KEY ELEMENTS: COORDINATION W/IL DOT 64C08

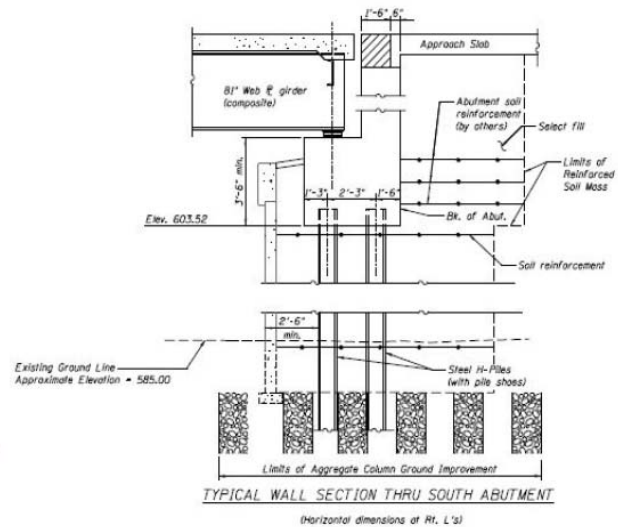
13. Where could I find the plans for proposed bridges SN 081-0177 and SN 0891-0178? Are they in another contract or a future project? Will piles and / or sleeves be in place before MSE wall is constructed? Is there a detail showing the connection between the C.I.P. abutment wall and the MSE walls on SN 081-6014?

RESPONSE: The plans for 081-0177 and 0178 are included in Contract 64C08, which extends from the Mississippi River to 7th in Moline. They can be viewed at <http://apps.dot.illinois.gov/eplan/desenv/061617/01X-64C08/> starting on Sheet 770. I have attached a page from the recent pre-bid meeting presentation that provides some clarification regarding the construction responsibilities and sequencing for the connection between the south abutment of the viaduct structure

and the MSE walls in this area. Specific details are also noted on Sheets 776 and 896 of the plans noted above, as well as Sheets 1287 and 1290 of the plans for Contract 64E26.

- Contractor 64E26
 - Construct ACGI
 - Construct MSE walls
- Contractor 64C08
 - Drive Piles
 - Construct abutment
 - Grade sub-base
 - Construct approach slab
